Access Compliance Report Public Rights-of-Way (Curb Ramps)

Main Street: RANCHWOOD_RD		Cross Street: LA_COLINA_DR		Location:	SE
ADA ID: RPRK211014133258	Ramp Type: Type 1 - Perpendicular Diagonal Initial Pass/Fail: Fail		Overall Compliance: No	Severity Score:	15

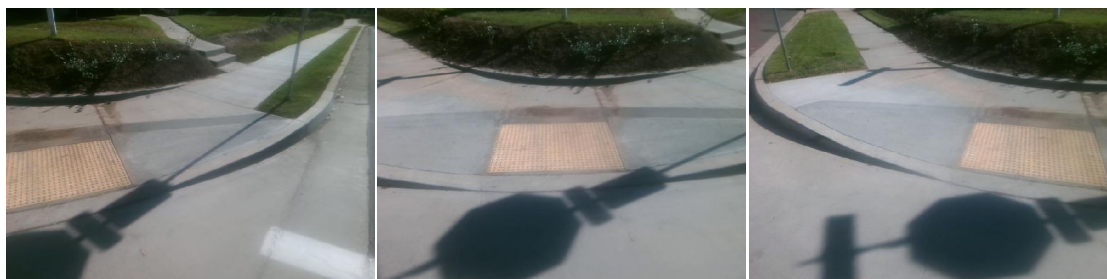
Compliance	Description	Data	Compliance	Description	Data
N/A	Ramp Length (in)	100	N/A	Flare Type LT	
Yes	Ramp Width (in)	48			N/A
No	Ramp Run Slope (%)	8.4	N/A	Flare Slope LT (%)	N/A
Yes	Ramp Cross Slope (%)	0.7	N/A	Flare Traversable LT	N/A
N/A	Landing Present	N/A	N/A	Flare Type RT	
N/A	Landing Length (in)	N/A			N/A
N/A	Landing Width (in)	N/A	N/A	Flare Slope RT (%)	N/A
N/A	Landing Run Slope (%)	N/A	N/A	Flare Traversable RT	N/A
N/A	Landing Cross Slope (%)	N/A	N/A	DWS Provided	N/A
N/A	Landing Movement Obstructed?	N/A	N/A	DWS Contrast	N/A
	Landing Movement Type	N/A	N/A	DWS Length (in)	N/A
N/A	Landing Shared	N/A	N/A	DWS Full Width	N/A
N/A	Clear Space	Yes	N/A	DWS Offset Left (in)	N/A
N/A	Clear Space To Crosswalk (in)	N/A	N/A	DWS Offset Right (in)	N/A
N/A	Marked Crosswalk 1	No	N/A	Marked Crosswalk 2	No
	Crossing 1 Direction	NW		Crossing 2 Direction	SW
	Marked Crosswalk 1 Width (in)	N/A		Marked Crosswalk 2 Width (in)	N/A

N/A	Ramp Inside Crosswalk 1	N/A	Yes	Ramp Inside Crosswalk 2	N/A
	Crossing 1 Slope (%)	8.3		Crossing 2 Slope (%)	12
	Crossing 1 Cross Slope (%)	2		Crossing 2 Cross Slope (%)	0.7
N/A	Gutter Ponding	N/A	No	Curb Slope	7.9
Yes	Gutter Lip Height (in)	0		Road Run Slope (%)	1.7
N/A	Gutter Run Slope (%)	N/A		Road Cross Slope (%)	5.2
N/A	Gutter Cross Slope (%)	N/A			
Yes	Overall Surface Condition: Acceptable		Yes	Perp Joint Present	Yes
	Cross Gutter Present?	Yes		Spandrel Present?	Yes
	Replace Cross Gutter?	No		Replace Spandrel?	No

Remove & Replace Curb Ramp With Two New Directional Ramps or Equivalent.

R304.2.2, STD 1115
